SPRING CREEK 2ND ADDITION

TO SEDGWICK COUNTY, KANSAS

S/D 98-48 -- Final Plat of SPRING CREEK SECOND ADDITION

CASE NUMBER: S/D 98-48 - SPRING CREEK 2ND ADDITION

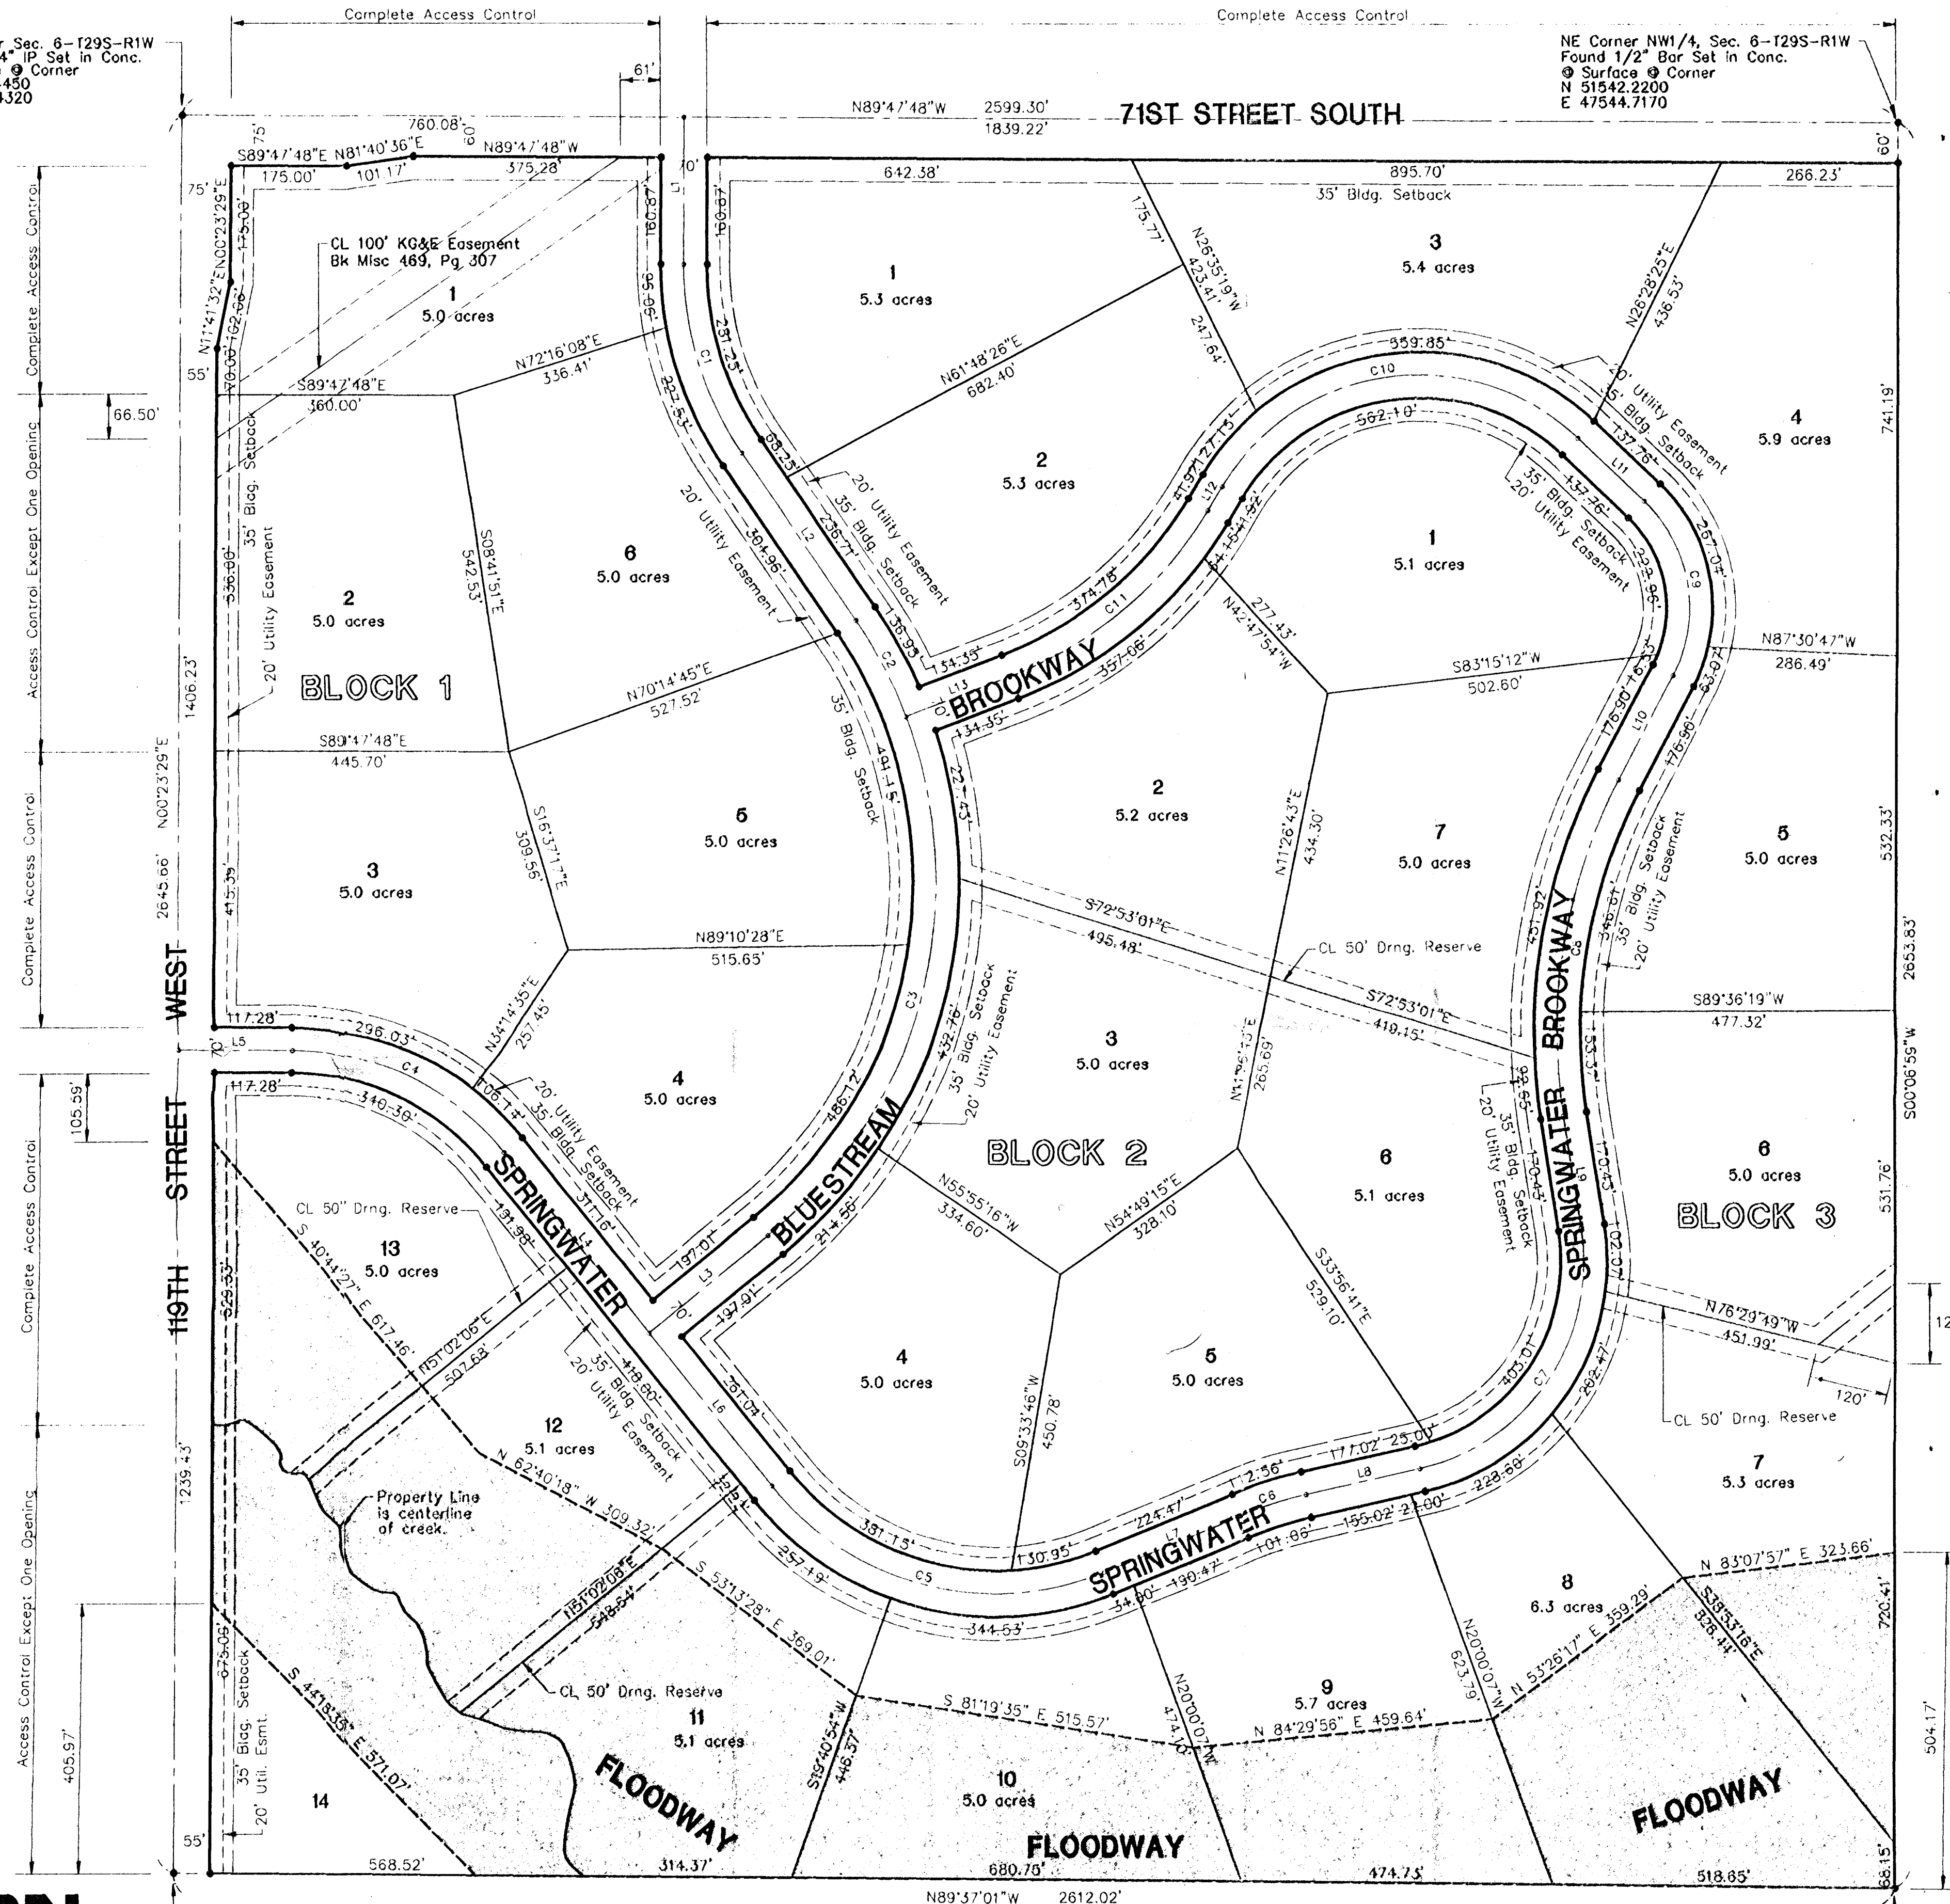
- F. Since the floodway is being platted, the standard floodway language shall be included in the plat's text.
- G. The tie points should be revised to read, "NE corner NW 1/4" and "SW corner of NW 1/4".

- H. County Engineering needs to comment on the need for improvements to perimeter streets. No improvements are needed.
- I. Lot numbers in each block should be revised in the final plat, to include consecutively numbered adjoining lots.

- J. County Fire Department needs to comment on the acceptability of the proposed street names. The suffix "drive" should be eliminated for the streets in this plat as it is only appropriate for streets parallel to that of a street of the same name.

- K. A contingent right-of-way dedication extending to the east line of the plat is recommended in order to provide potential street connection between this property and the property to the east.

- C. County Engineering needs to comment on the status of the applicant's drainage plan. Flood elevations need to be established. FEMA approval will be needed if floodplain width is to be reduced. The drainage easements need to be increased to 50 feet and relabelled as drainage reserves.

- F. The County Commissioners signature block need only include the signature of the Chairman.
- G. The tie points should be revised to read, "NE corner NW 1/4" and "SW corner of NW 1/4".

- I. Lot numbers in each block should be revised in the final plat, to include consecutively numbered adjoining lots.
- J. County Fire Department needs to comment on the acceptability of the proposed street names. *The suffix "drive" should be eliminated for the streets in this plat as it is only appropriate for streets parallel to that of a street of the same name. Artesian Drive shall be eliminated.*

- K. *The floodway language in the plat's text shall be revised to reference "the engineer of the appropriate governing body" rather than the "Wichita Valley Center Flood Control Office".*
